E4417A-15A

S E R V I C E N O T E

E4417A EPM-P Power Meter

Power Meter Display Shrink

Figure 1

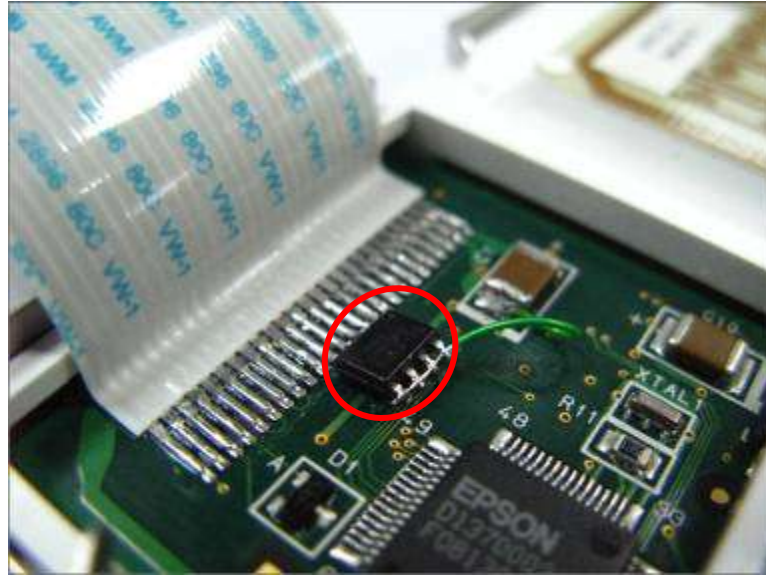
Due to some issues with the implementation of new LCD display controller in the power meter's display, intermittent display shrink is observed when operating the power meter. This however doesn't impact all the units. The display shrink scenario may look like something shown below:

To resolve this problem, replace the front panel assembly with a good one. A good front panel has additional Transient Voltage Suppress (TVS) diode soldered on its PCA **OR** additional ribbon cable with Damping Resistors attached to it. The photos for good front panel assembly are shown below. Additional of TVS diode **OR** Damping Resistors will prevent the display shrink from happening.
